REVISION LOG

Lot 9 Duncan's Creek
67 Beacon Hill Drive

The Hanover Low Country - RH

THE HANOVER - RH
Cover - Low Country

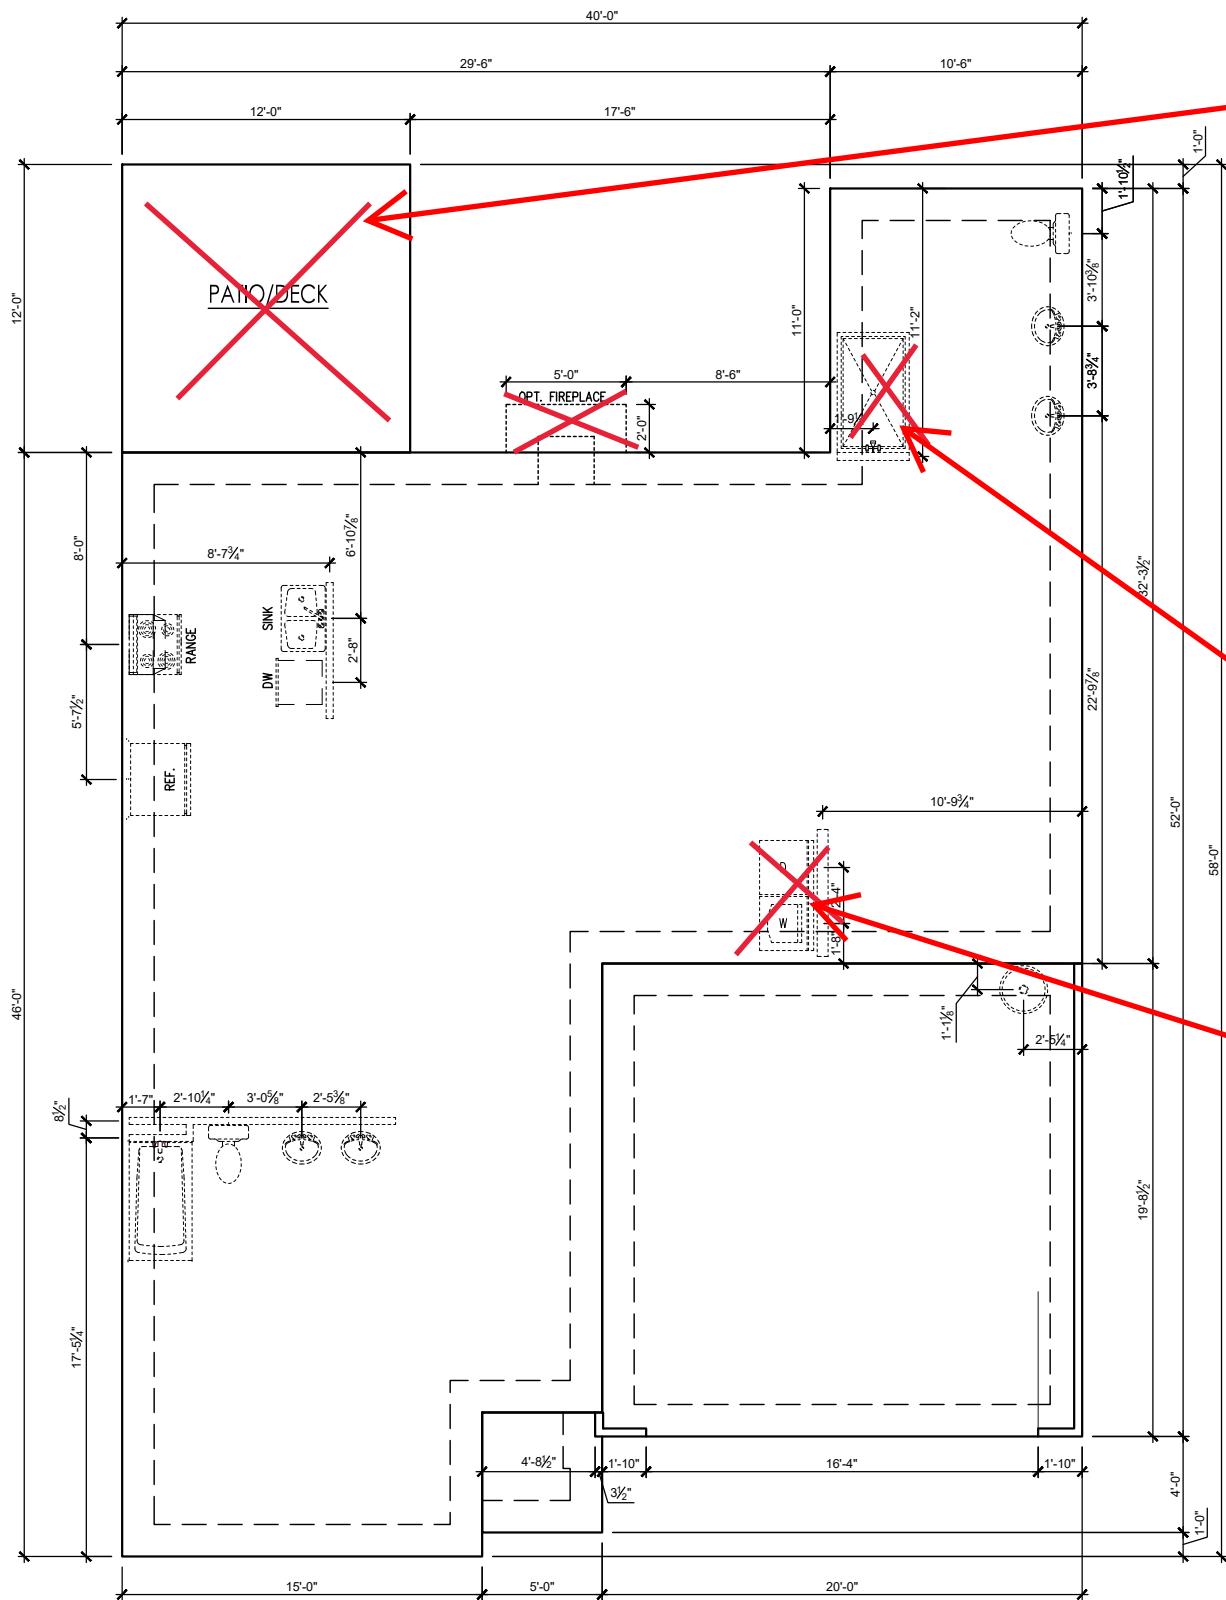
← should be 144 sq

FOUNDATION- SLAB
SCALE: 1/4" = 1'-0" ON 22x34, 1/8" = 1'-0" ON 11x17

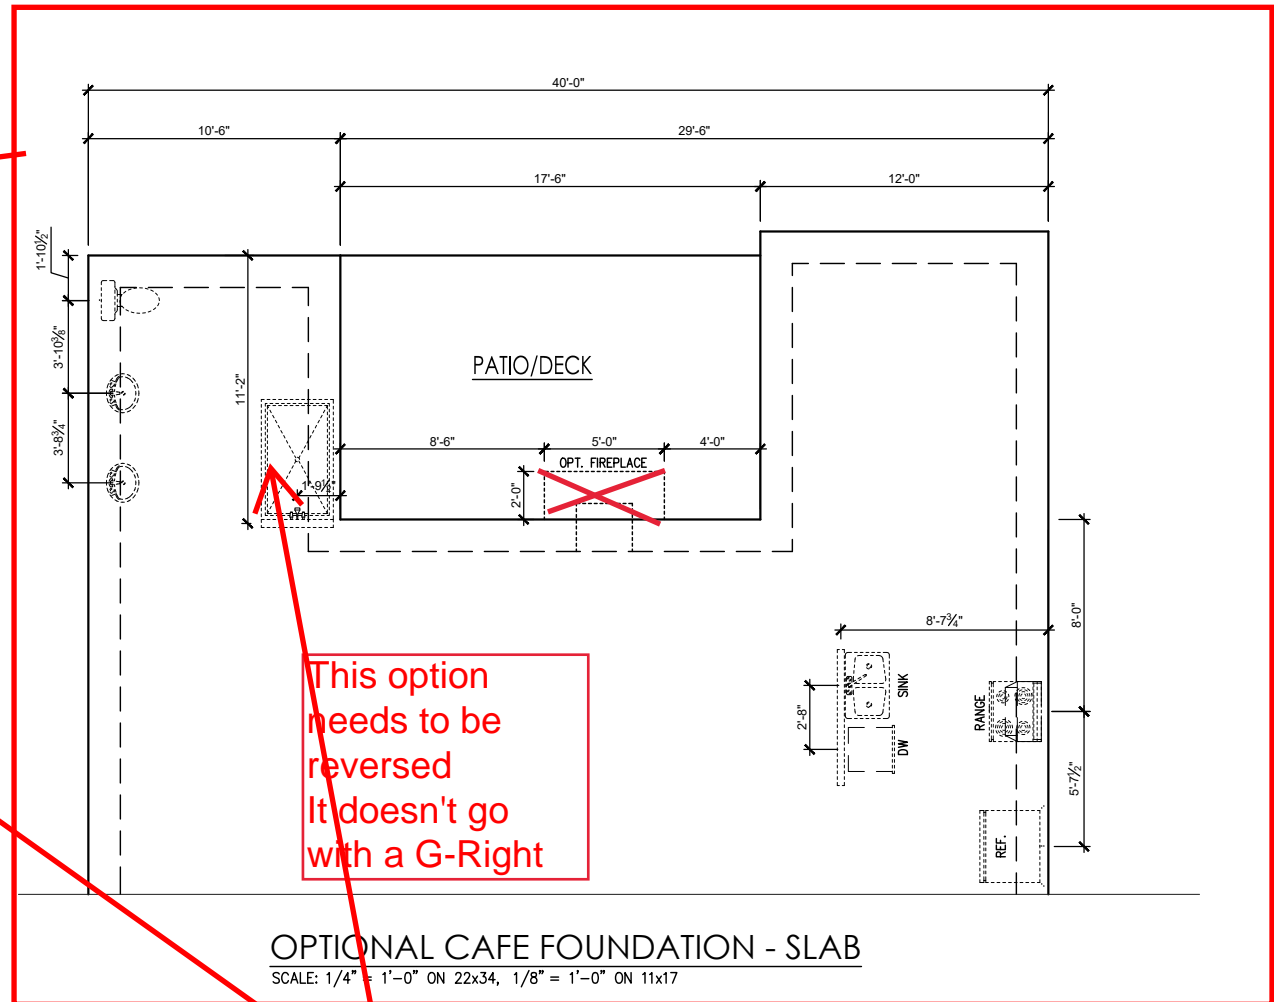
This option needs to be reversed
It doesn't go with a G-Right

REAR ELEVATION (SLAB)

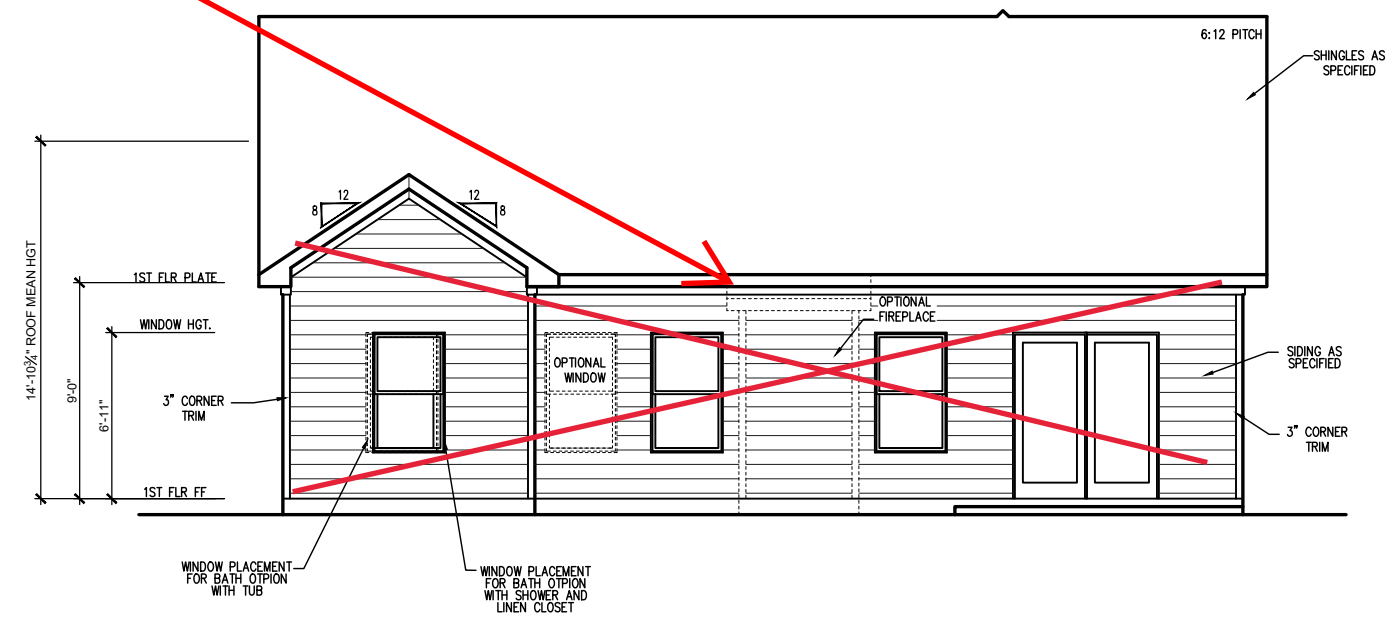
Insert Rear Elevation
see Page 3.2

Side Elevations - Low Country (Slab)

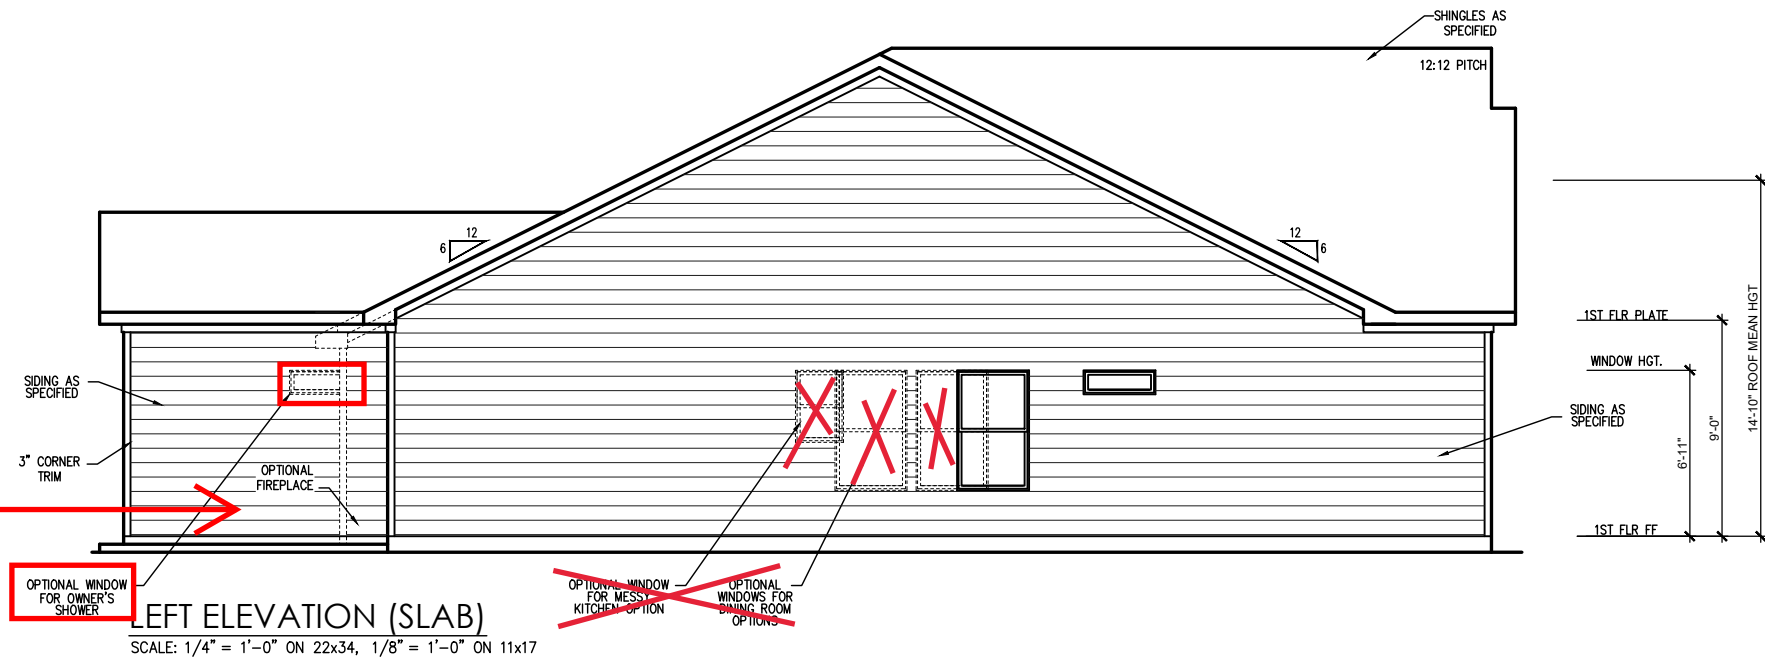
Insert applicable side elevation
see Page 3.2

FOUNDATION PLAN
MONOSLAB OPTION 1/4" = 1'-0"

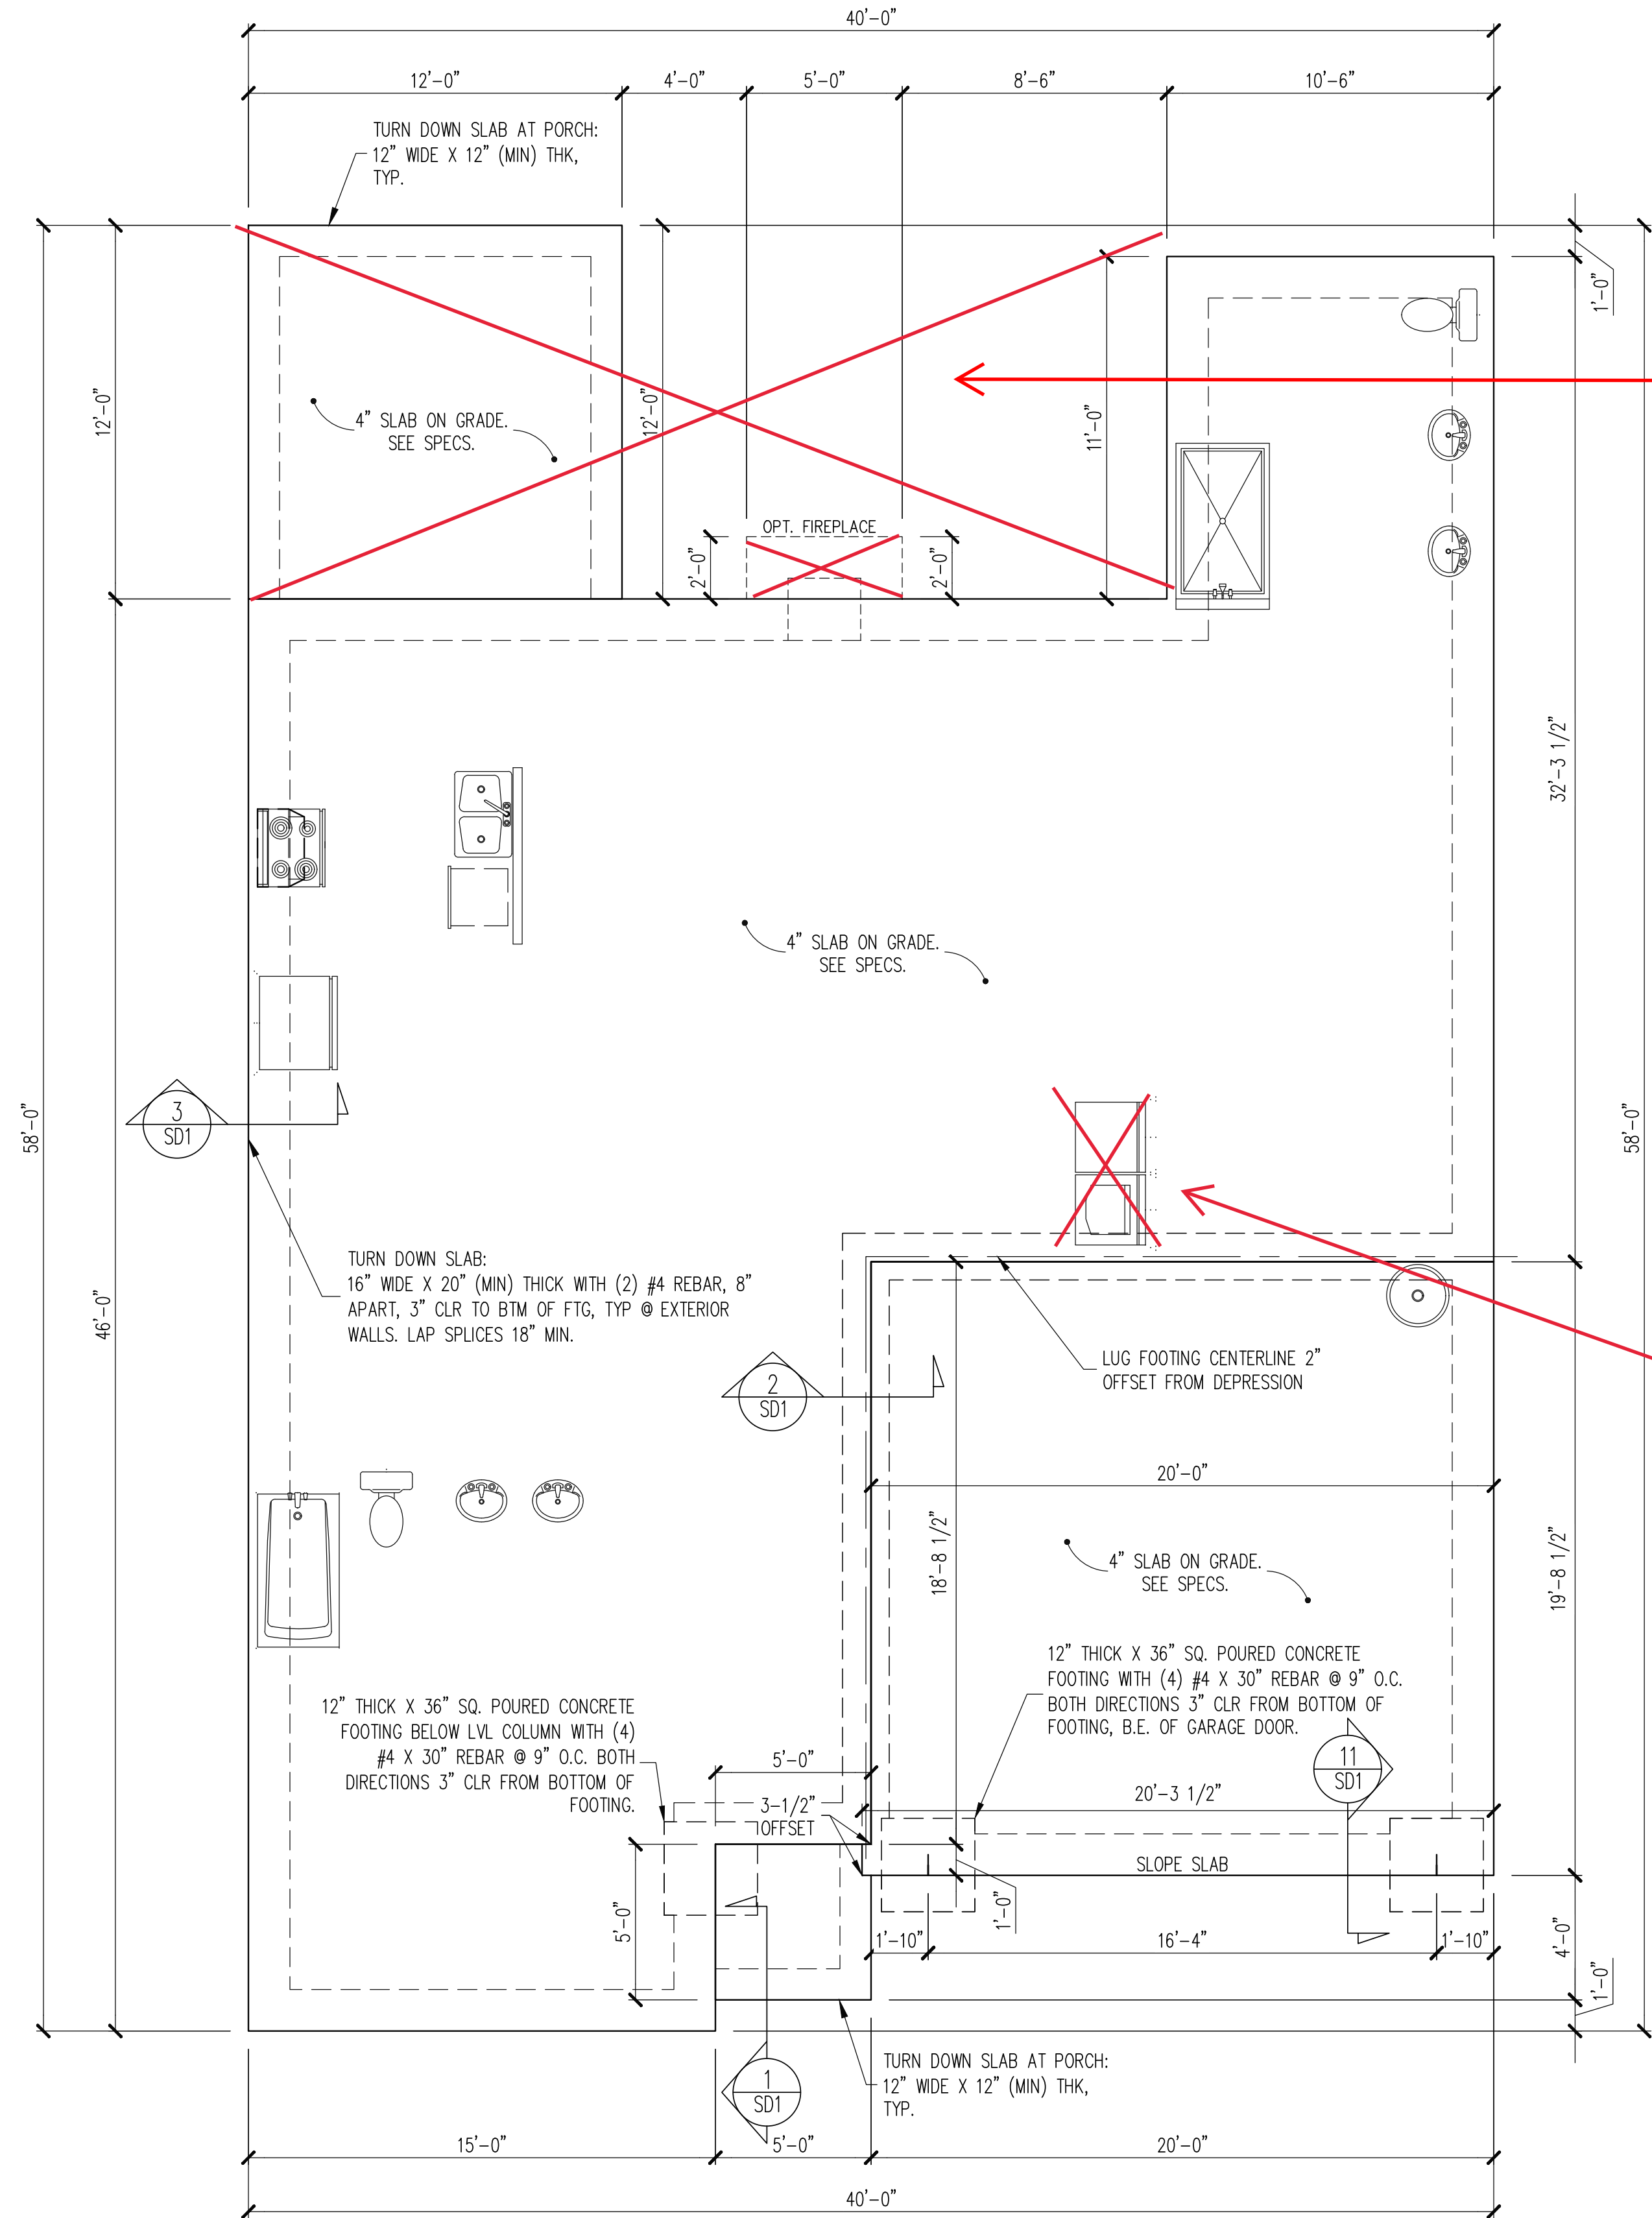
Opt Laundry Entry from Owner's
see Pages 2.1 & S5
